50-348/364-CIVP
2/19/92DOCKETED
USNRC

Staff Exh. 46

HCS Prohibited Violations:

FIGURE 1

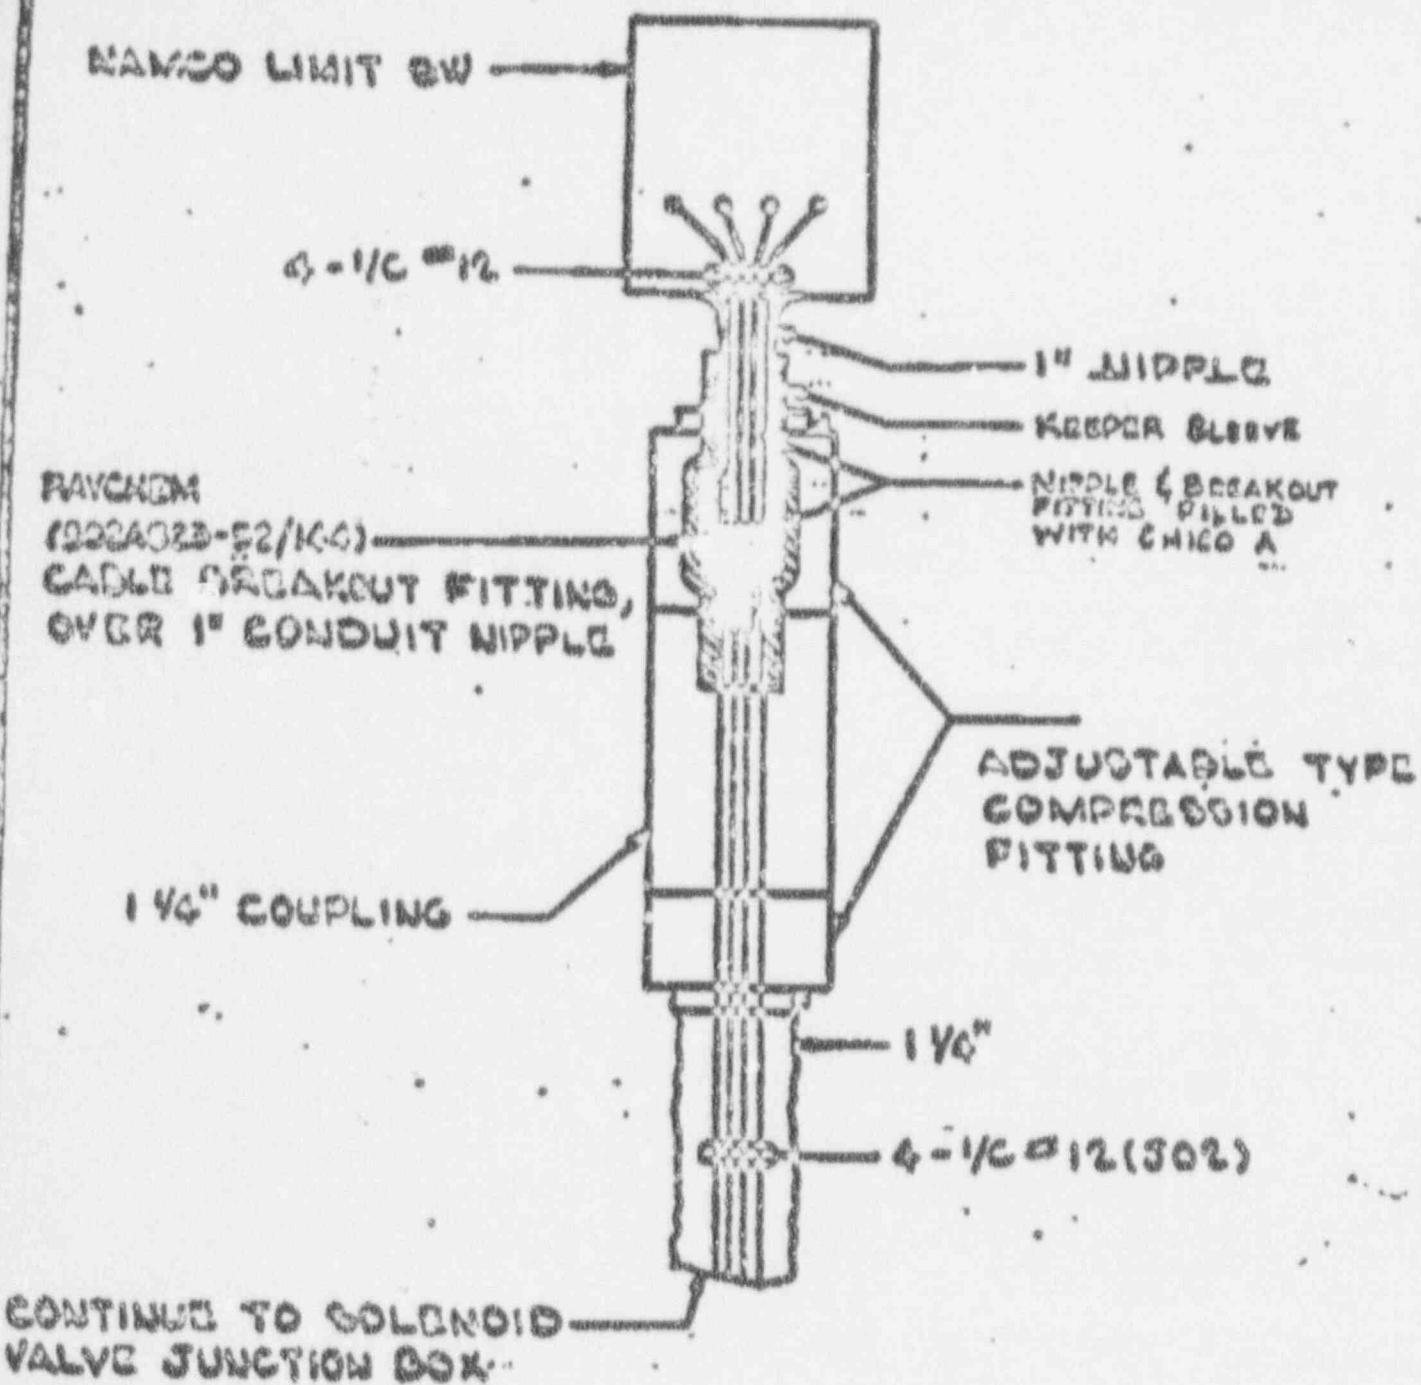
The Chico Seal qualification package has not demonstrated that Raychem will bond to conduit.

The environmental seals used with NAMCO EA-100 limit switches are composed of a Raychem NCSE breakout boot that has been shrunk onto a 1" pipe nipple attached to the limit switch (See Figure 1). The individual conductors connected to the switch pass through the breakout boot which forms a seal to the conductor insulation/jacket. To provide mechanical rigidity to the breakout boot, the nipple and the breakout boot are filled with Crouse-Hinds sealing compound (CHICO A) and allowed to cure. In addition to providing mechanical rigidity to the breakout boot crotch, the CHICO A provides an additional pressure tight barrier (seal) inside the pipe nipple which is environmentally qualified. CHICO A was qualified by test conducted by Southwest Research Institute (SRRI Project No. 03-4974-031) for use as drywell penetrations for Grand Gulf Nuclear Station. In addition, on the recommendation of Raychem, a keeper sleeve was installed over the breakout boot and the nipple to add rigidity to the boot, and to keep the boot in place during elevated accident temperatures when the adhesive softens.

In the final assembly, an appleton compression adaptor is clamped over the keeper sleeve to provide support for the flexible conduit, and it also mechanically clamps the keeper sleeve to the pipe nipple.

The zinc coating on the galvanized steel nipple may interact with the chemical spray curing LOCA and form a gray powder over the nipple. However, the chemical spray does not react with the Raychem S1119 adhesive (Reference Kyle Test Report No. 58442-2, Section 3.4, Page 9 and Section 3.4.2). In addition to the duration of spray at Farley is only 67 minutes and the individual conductors will be effectively shielded from the spray.

Should there be a failure of the adhesive between the pipe nipple and the breakout boot, for whatever reason, the seal assembly would remain intact because of the keeper sleeve and the clamping action of the compression adapter. If it is postulated that the breakout boot, the keeper sleeve and the compression adapter clamp all fail, the internals of the NAMCO limit switch will still be protected by the approximately 3 inch long CHICO A seal.
